RE: Dominion Possum Point Power Station VPDES Permit No. VA0002071
Permit Modification Request

Virginia Electric & Power Company d/b/a Dominion Virginia Power (Dominion) is submitting the enclosed application to modify the subject permit for the following reasons:

Dominion Possum Point Power Station
VPDES Permit No. VA0002071
Permit Modification

**SITE PLAN
DRAINAGE AREA
POSSUM POINT POWER STATION**

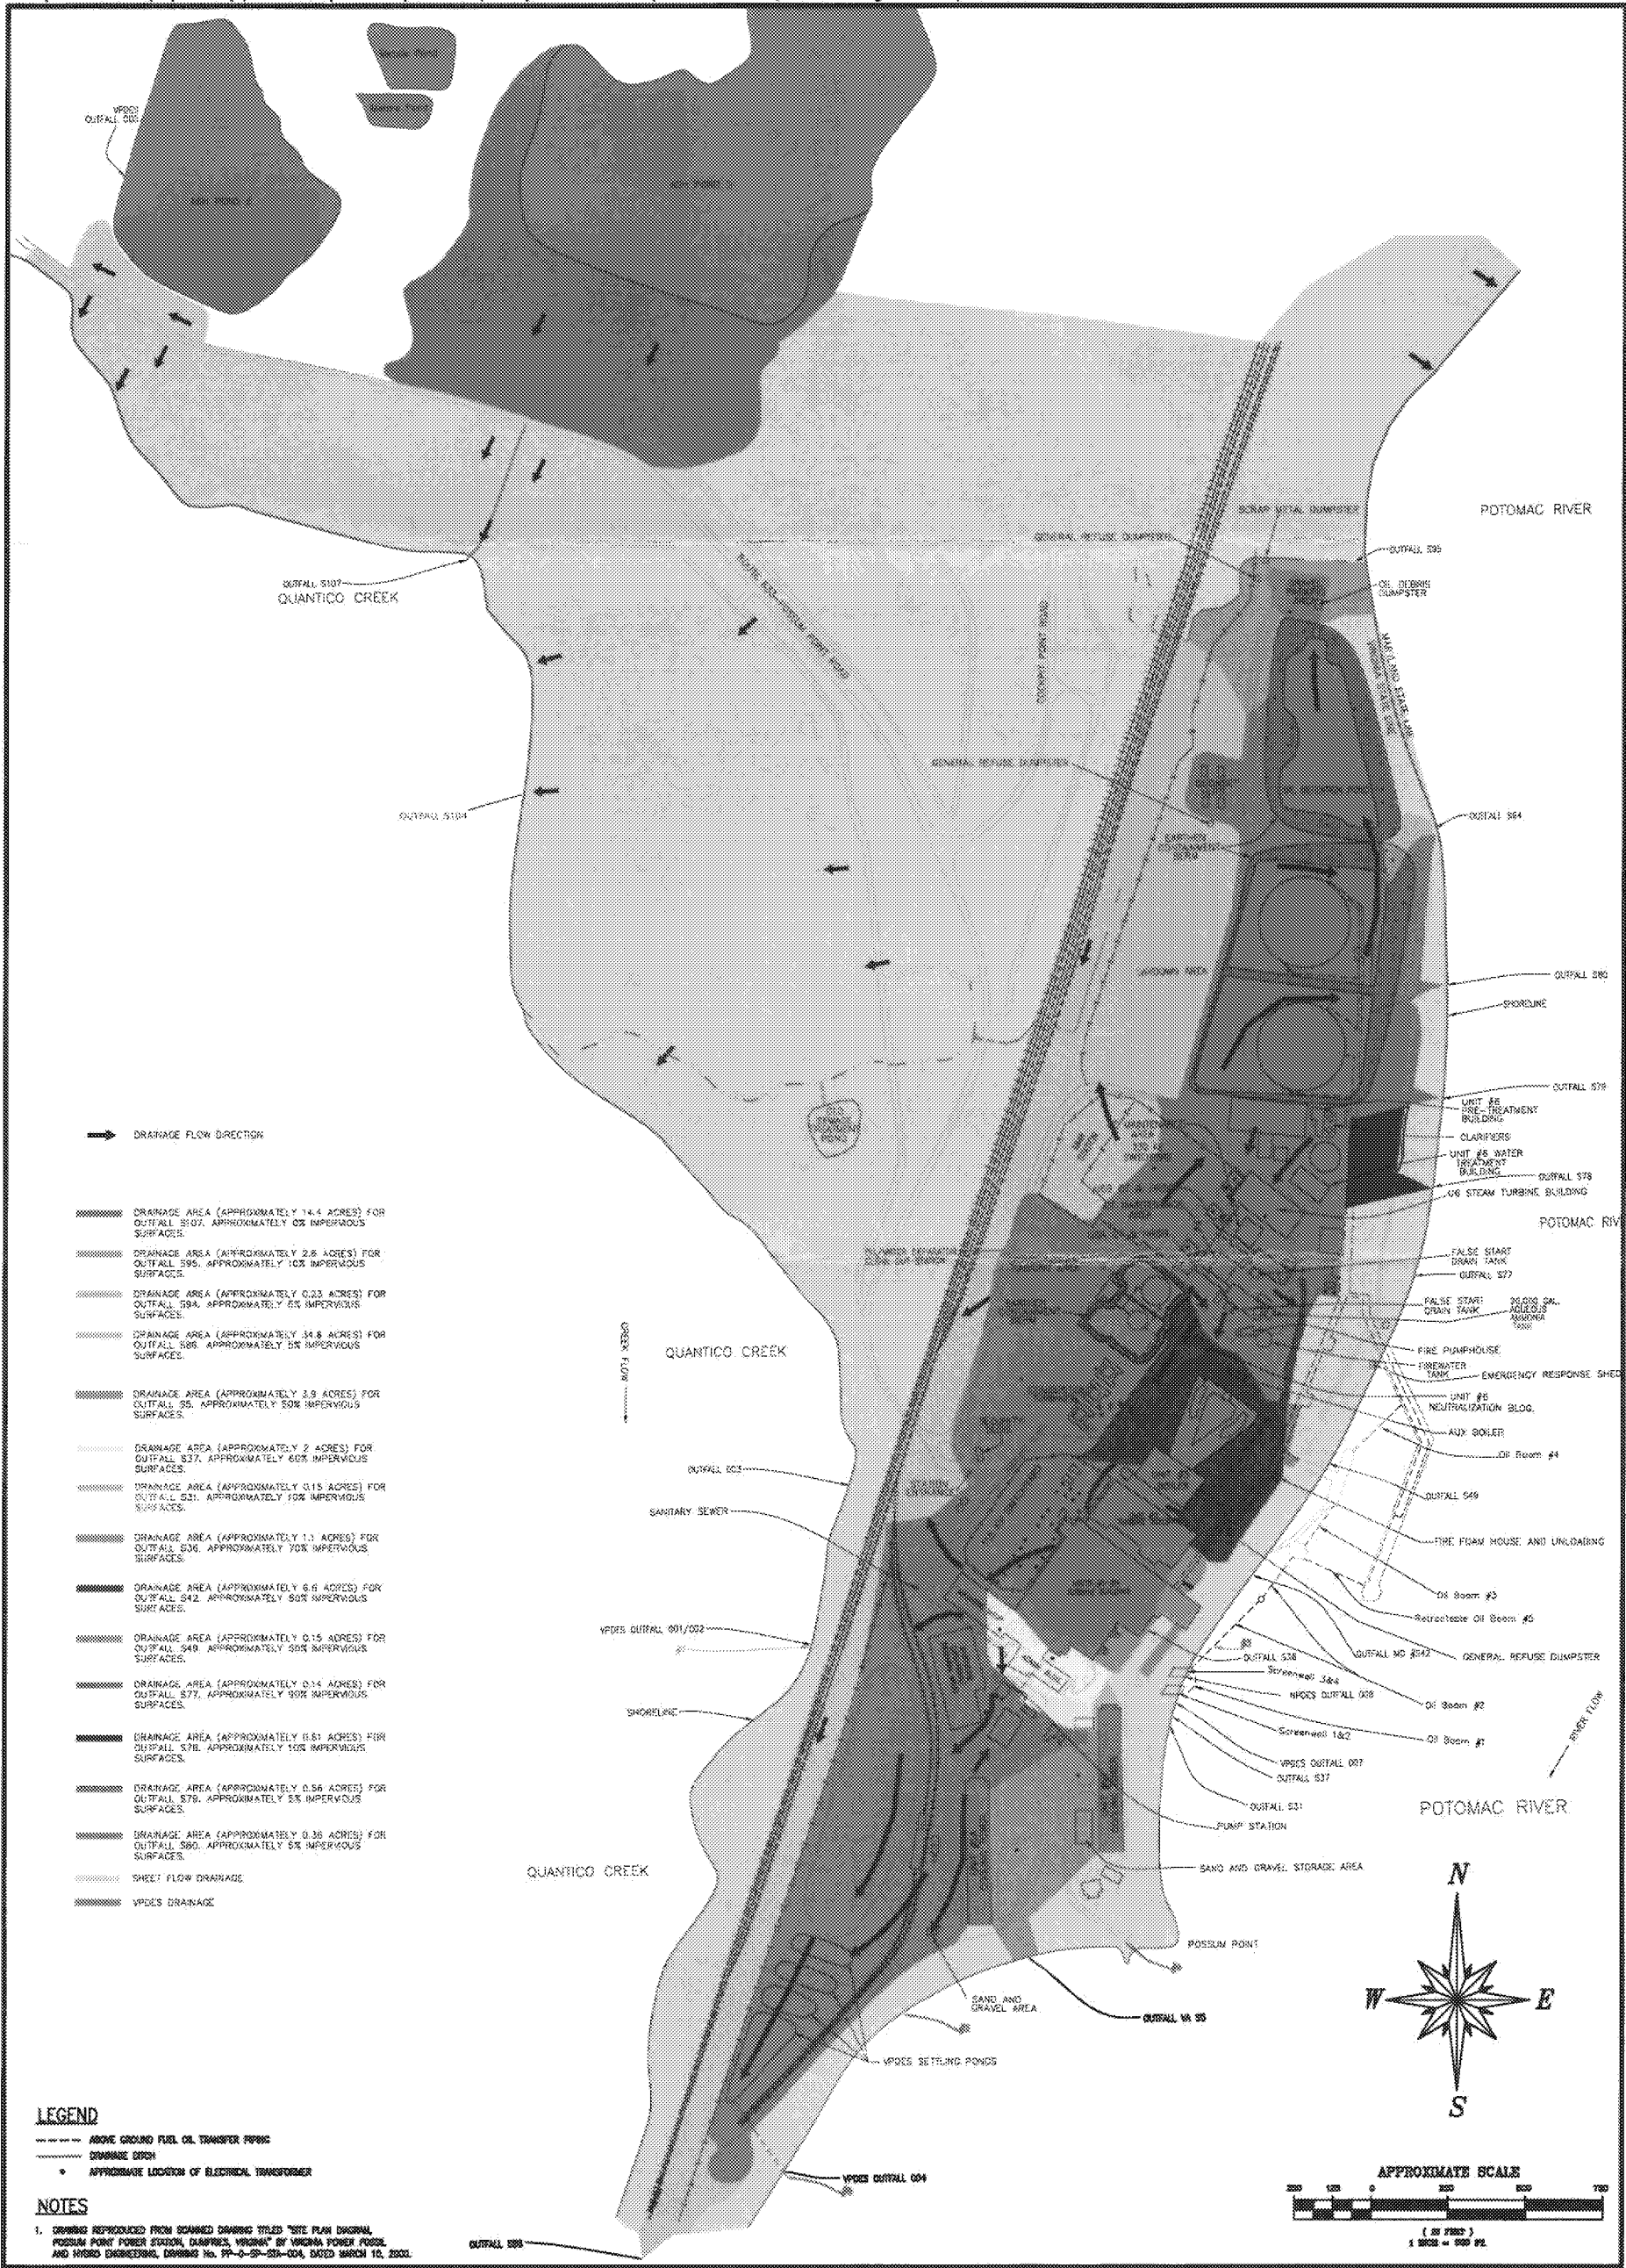
See Attachment A for description of the drainage area contributing to Outfall S104.

| Outfall Number | Treatment | List Codes from Table 2F-1 |
|----------------|---|----------------------------|
| S104 | Stormwater contributing to Outfall S104 originates from areas of the station where no industrial activities are currently located. If improvement activities require that ash is disturbed, then best management practices (e.g., straw bales, silt fences, check dams) will be utilized to reduce associated pollutants in storm water runoff. | 1-O, 4-A |

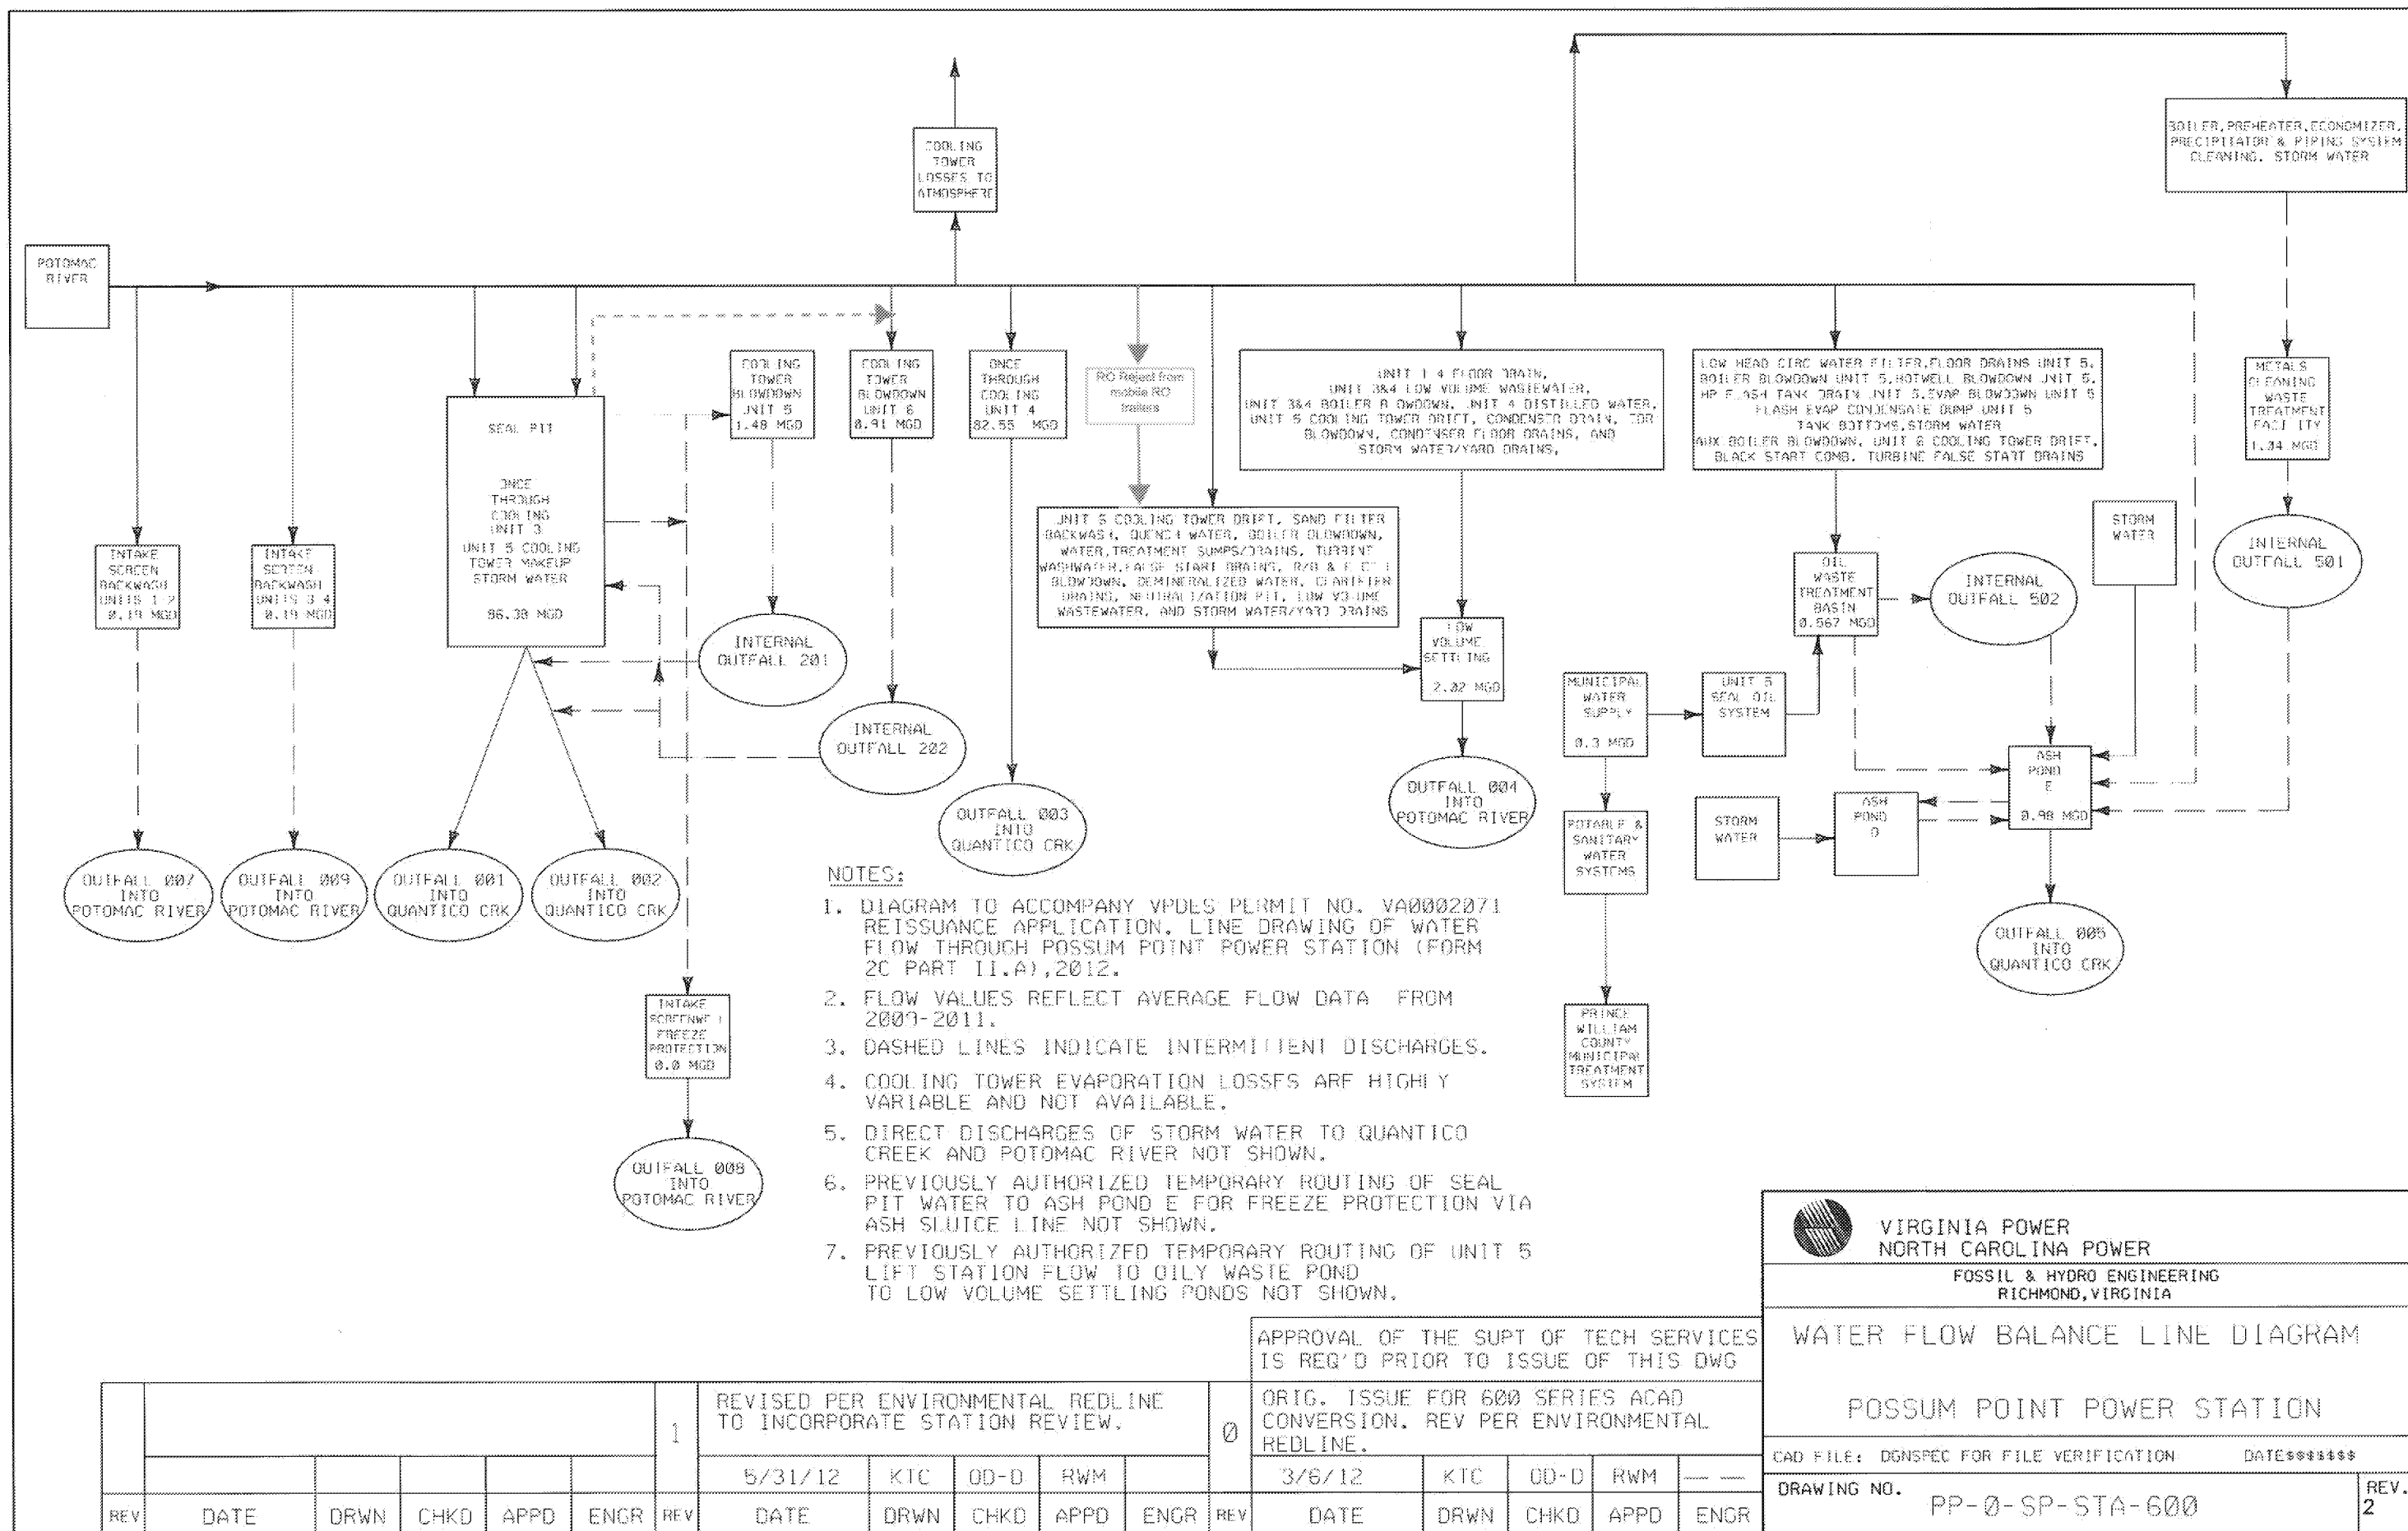
2. We request that DEQ approve the use of water from the Seal Pit as back-up raw water supply for Unit 6. The updated flow diagram reflects the change, which should have no impact to Outfall 001/002 discharge.

3. Since Outfall 007 (Intake Screen Backwash Water) is the primary Outfall for the Units 3, 4, 5 and 6 intake screen backwash water, and Outfall 009 is an intermittent discharge and only includes discharges from Units 3&4 intake screen backwash, the station would only use Outfall 009 if the bridge and trough connecting the intakes fails. Outfall 007 and 009 would be separate until repairs are made to the bridge and trough. For this reasons, we request that the DEQ rewords the descriptions for Outfalls 007&009 in Part I A of the permit (pages 5 & 7) as follows:

5. **Outfall 007 – Intake Screen Backwash Water** ~~(Units 5 and 6 formerly Units 3 and 2)~~ (Units 3, 4, 5, and 6)
 - a. There shall be no discharge of floating solids or visible foam in other than trace amounts.
 - b. During the period beginning with the permit's effective date and lasting until the expiration date, the permittee is authorized to discharge from Outfall Number 007. Such discharges shall be limited and monitored by the permittee as specified below.
 - c. ~~The permittee is authorized to discharge Intake Screen Backwash Water from Units 3 and 4 through Outfall 007 until such time that Outfall 009 is operational.~~

7. **Outfall 009 – Intake Screen Backwash Water (Units 3 and 4)**
 - a. There shall be no discharge of floating solids or visible foam in other than trace amounts.
 - b. During the period beginning with the permit's effective date and lasting until the expiration date, the permittee is authorized to discharge from Outfall Number 009. Such discharges shall be limited and monitored by the permittee as specified below.
 - c. ~~Until such time that Outfall 009 is operational, the permittee is authorized to discharge Intake Screen Backwash Water from Units 3 and 4 through Outfall 007~~
